**WIDEFIELD WATER AND
SANITATION DISTRICT**

2 MG ROLLING HILLS TANK

**SITE DEVELOPMENT PLAN
DRAINAGE LETTER**

**RE: Widefield Water and Sanitation District
2 MG Potable Water Tank
1041 Submittal – Drainage Letter
Address: TBD (Schedule 5500000385)**

WIDEFIELD WATER AND SANITATION DISTRICT
 ROLLING HILLS 2MG POTABLE WATER TANK AND INLET PIPELINE
 SITE DEVELOPMENT PLAN
 PROPOSED SITE DRAINAGE

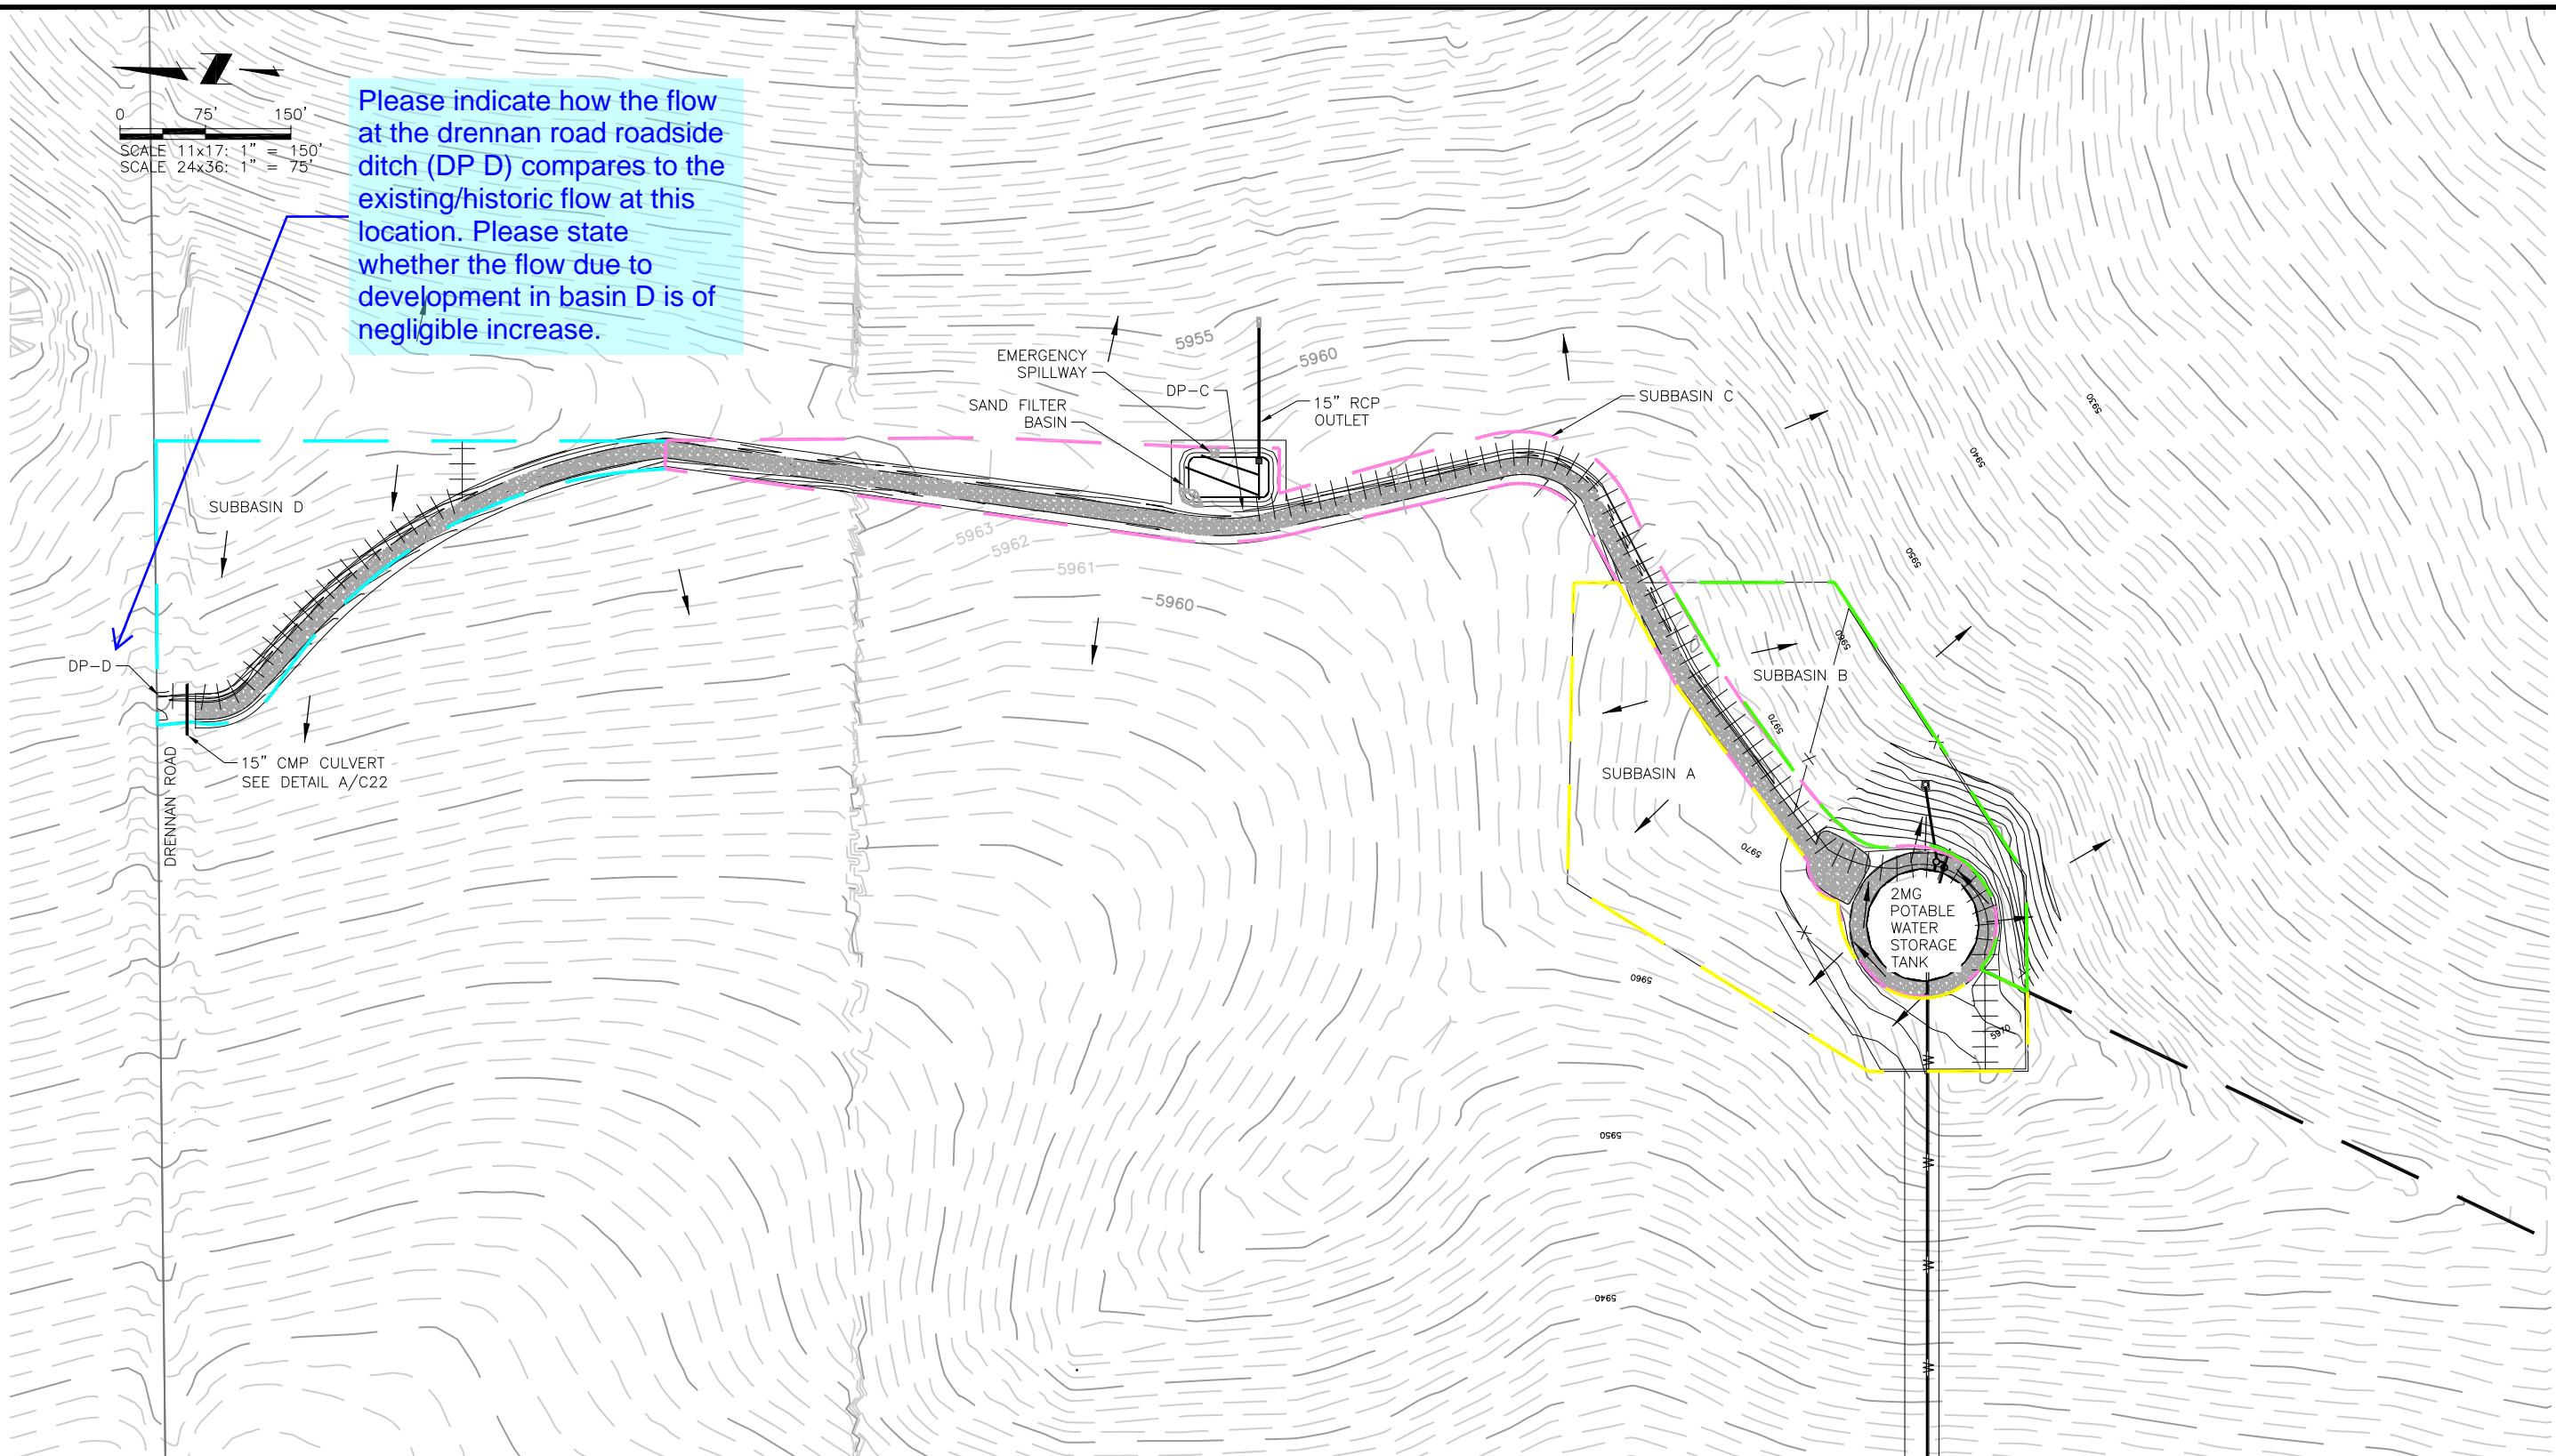
Please indicate how the flow at the drennan road roadside ditch (DP D) compares to the existing/historic flow at this location. Please state whether the flow due to development in basin D is of negligible increase.
